Access Compliance Report

Public Rights-of-Way

(Curb Ramps)

Intersection ID: 11431	Main Street: N_GRAHAM_ST	Cross Street: W_9TH_ST	Location: N
ADA ID: 9CECDF45DDAB	Ramp Type: PerpDiag	Initial Pass/Fail: Pass	Overall Compliance: No
Severity Score: 5			
Codes/Mitigation Info/Possible Solution		Field Measurements/Component Compliance

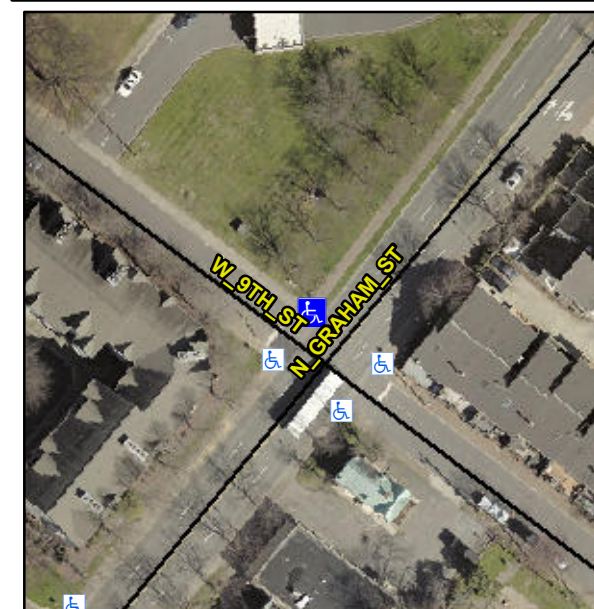
Remove & Replace Detectable Warning System. Remove & Replace Gutter.

R305.2, R304.5.4
